Delegated Decision Report

Application No:	24/1043	Statutory Period Expires:	23rd May April 2025
------------------------	----------------	----------------------------------	---------------------------------------

Site:	Gwent Car Sales Crawford Street Newport NP19 7AY		
Proposal:	PARTIAL DISCHARGE OF CONDITIONS 2 (FINISHED SLAB LEVELS), 4 (FOUNDATION DESIGN), 8 (RETAINING WALLS, PARAPET AND RAMP DETAILS), 9 (MEANS OF ENCLOSURE), 10 (GREEN ROOF DETAIL), 11 (ULEV SCHEME), 12 (MATERIALS), 13 (ECOLOGICAL ENHANCEMENT) AND 14 (DRAINAGE SCHEME) OF 22/1033 DEMOLITION OF EXISTING BUILDINGS AND THE CONSTRUCTION OF 30NO. APARTMENTS ALONG WITH ASSOCIATED PARKING AND EXTERNAL AREAS (AMENDED PLANS RECEIVED)		
Applicant:	J Moore		
Type:	Discharge Conditions	Ward:	St Julians
Decision:	APPROVED

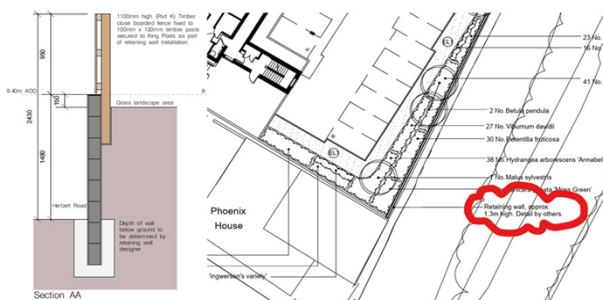
The ramp appears to be set back approximately 5m, behind highway, but the scales are not standard/available on a scale rule, and we are unable to print or measure accurately. The ramp appears to be around 1:11 approximately. This is very steep but given the set-back it is accepted. There are therefore no objections to partial discharge of condition 8.
